**SUBJECT:** Savannah River Site's Responses to the Regulatory Comments on the Performance Evaluation Report for the A-Area Burning/Rubble Pits (731-A, -1A) and Rubble Pit (731-2A) and the Miscellaneous Chemical Basin/Metals Burning Pit (731-4A, -5A) Operable Unit - January through December 2020 (U) (SRNS-RP-2021-00584, Revision 0, May 2021) SEMS Number: 28

SRS Responses to  
South Carolina Department of Health and Environmental Control Comments on:  
Performance Evaluation Report for the A-Area Burning/Rubble Pits (731-A, -1A) and  
Rubble Pit (731-2A) and the Miscellaneous Chemical Basin/Metals Burning Pit (731-4A, -5A)  
Operable Unit – January through December 2020 (U)  
SRNS-RP-2021-00584, Revision 0, May 2021, SEMS Number: 28  
Comments received September 8, 2021.

**SRS Responses to  
U.S. Environmental Protection Agency Comments on the  
Performance Evaluation Report for the  
A-Area Burning/Rubble Pits (731-A, -1A) and Rubble Pit (731-2A) and  
the Miscellaneous Chemical Basin/Metals Burning Pit (731-4A, -5A) Operable Unit,  
January through December 2020 (U)  
SRNS-RP-2021-00584, Revision 0 May 2021, SEMS Number: 28  
Savannah River Site, Aiken, South Carolina  
Comments

Figure 5. ABRP TCE Soil-Gas Vapor Levels

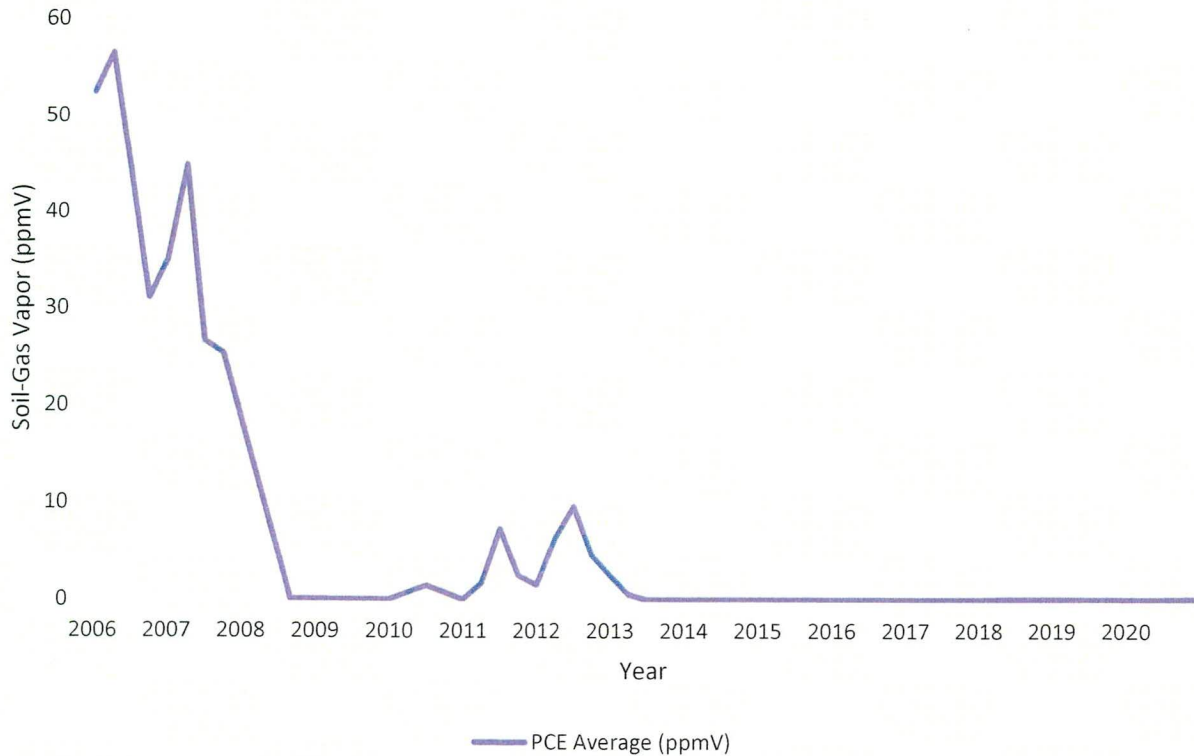
3. **Section 4.3, Overall Recommendations, Page 10 of 46:** The PER does not present a soil-gas vapor concentration over time trend diagram to support that soil-gas levels have reached asymptotic levels. For example, the text indicates the soil-gas vapor samples have remained at very low (near the laboratory detection limits) asymptotic levels VOCs are no longer productively being removed from and VOCs are nearly depleted; however, no trend diagram was presented. *Please revise the PER to present a vapor concentration over time trend diagram to support that soil-gas levels have reached asymptotic levels.*

**Response:** Agree. Figures 5 and 6 will be added to the next PER to present vapor concentration over time trend diagrams to support that soil-gas levels have reached asymptotic levels. Section 4.3 will be revised in the next PER submittal to reference the new trend diagrams.
